Addendum No. 2

*Farmers Alliance Mutual Insurance
1122 North Main Street
McPherson, Kansas 67460*

Architect's Project Number: 22.31

Addendum No. 2 (Articles 2.1 thru 2.3) 1 Pages + Attachments

SHEET NUMBER
A010

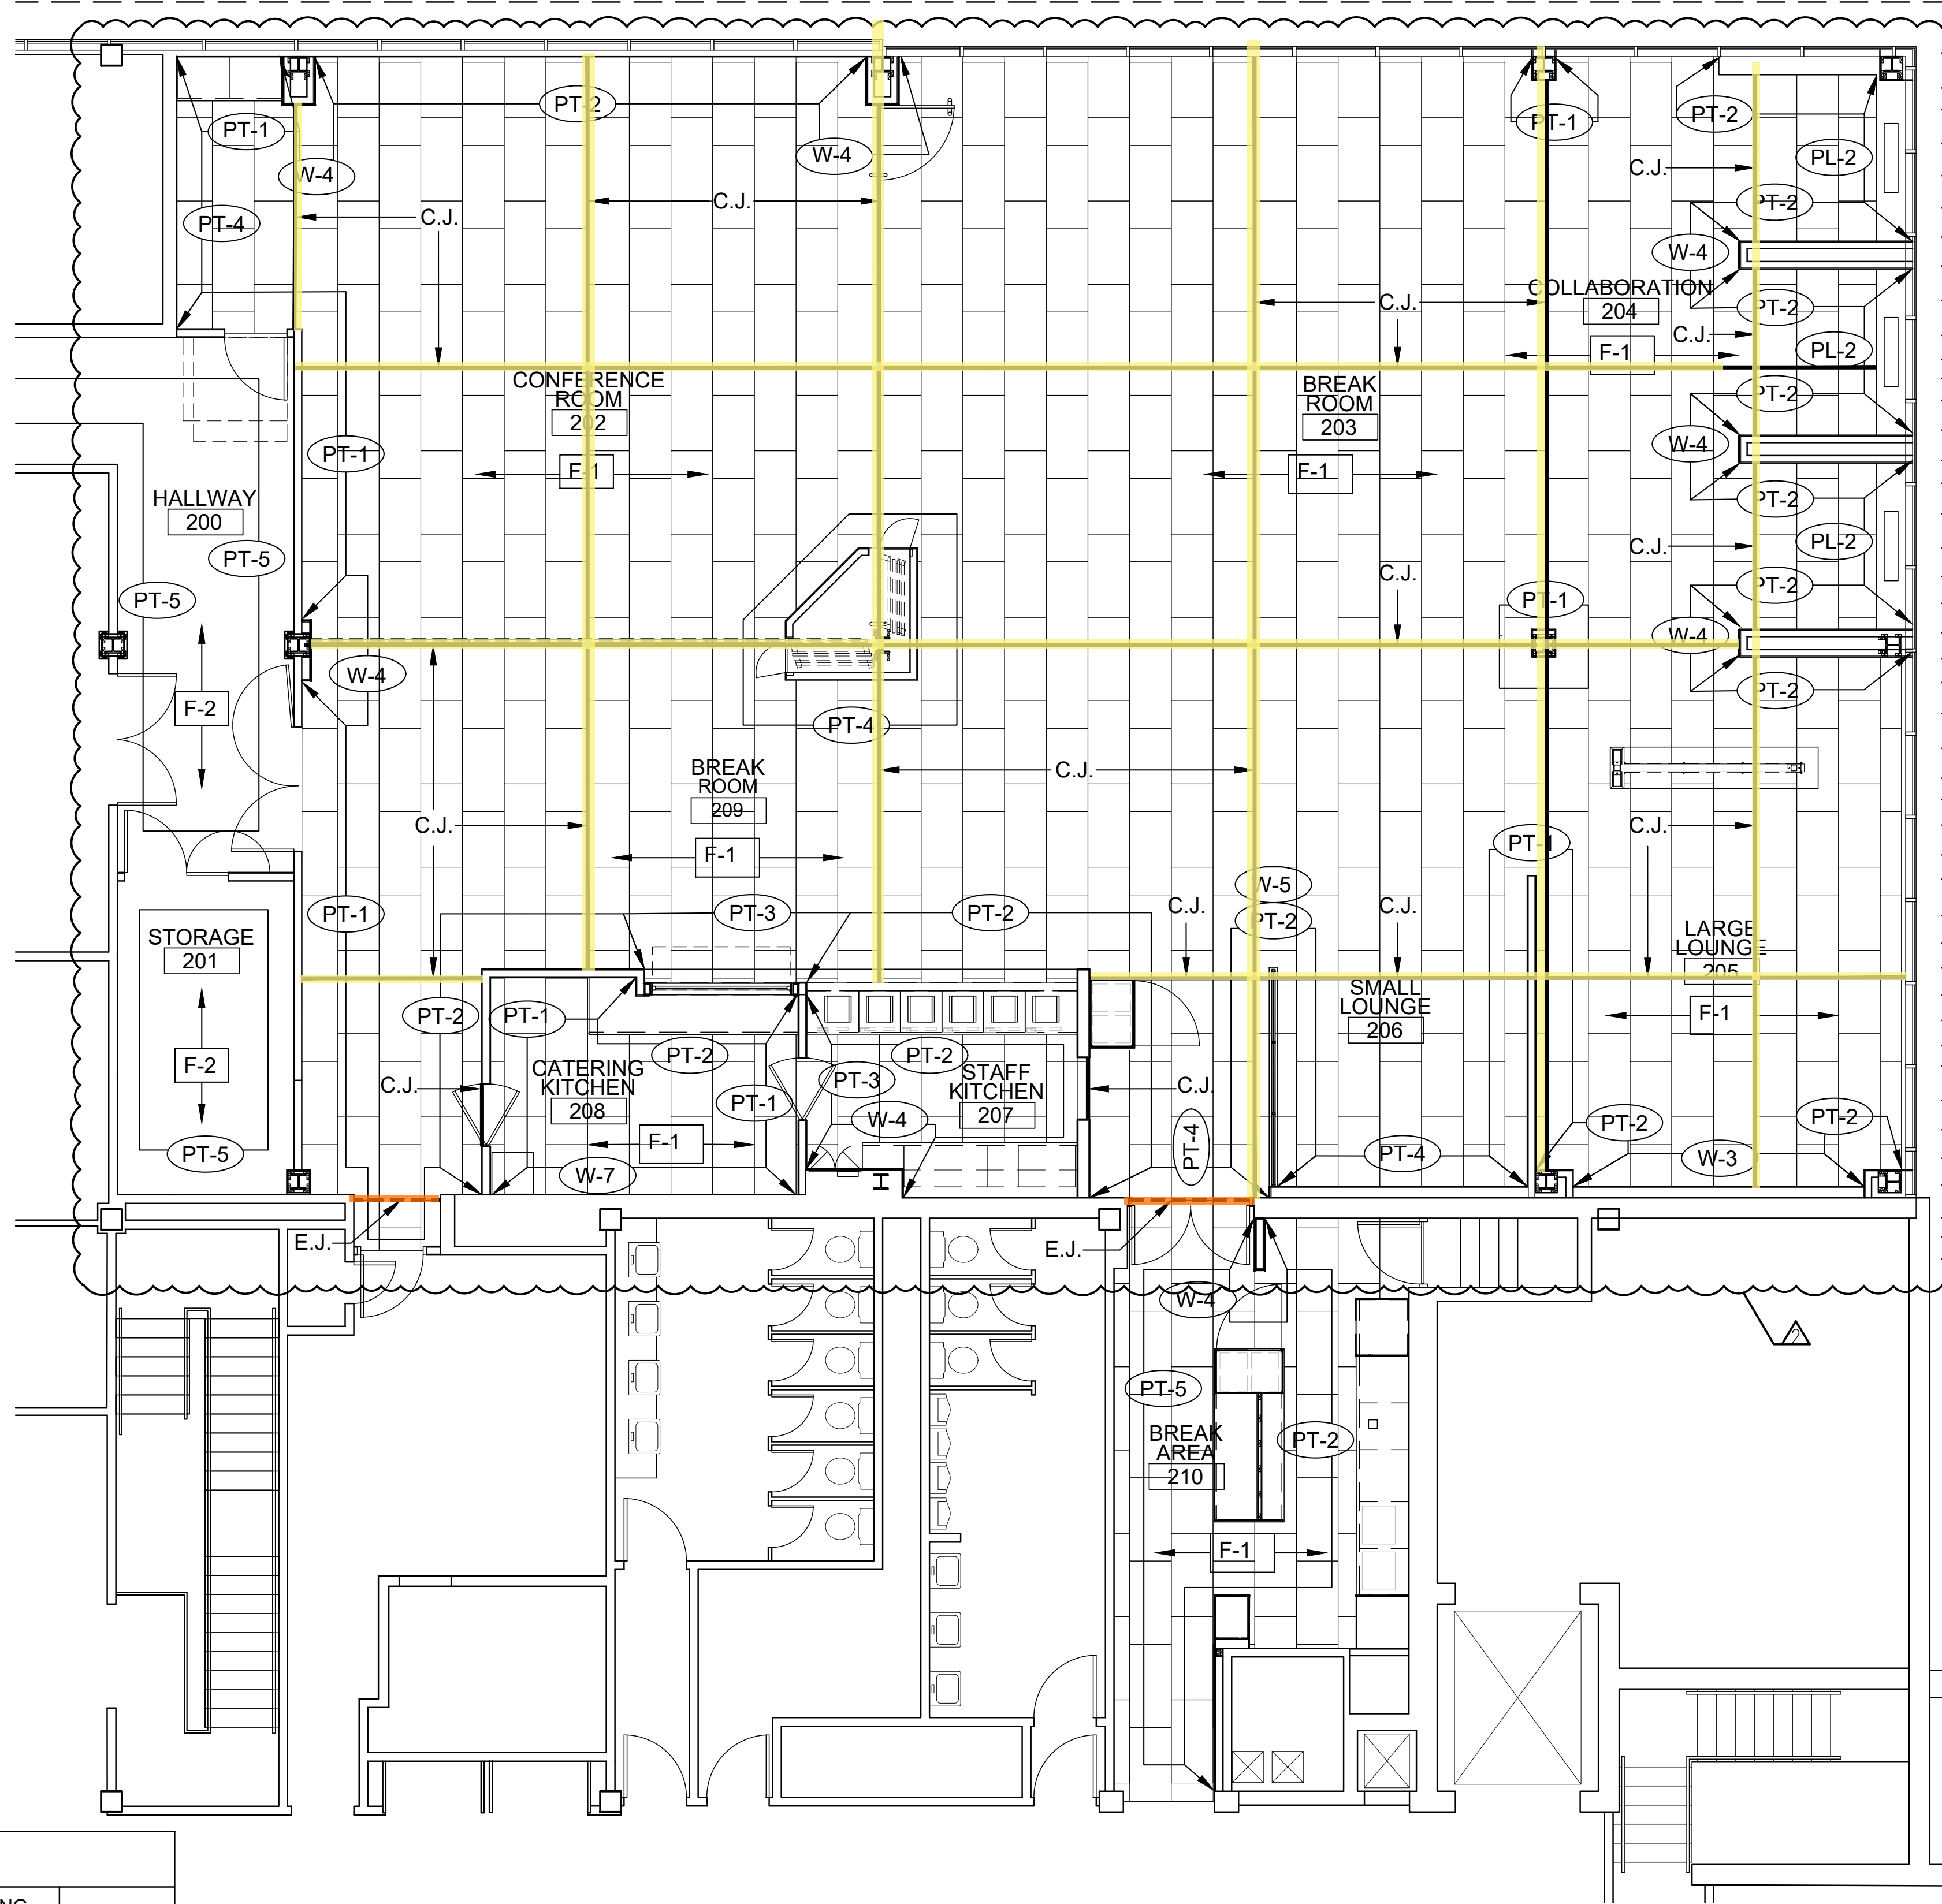
Article 2.2. Architectural: A010 Finish Schedule (See Attached)

A. **Add** floor tile control joints and expansion joints.
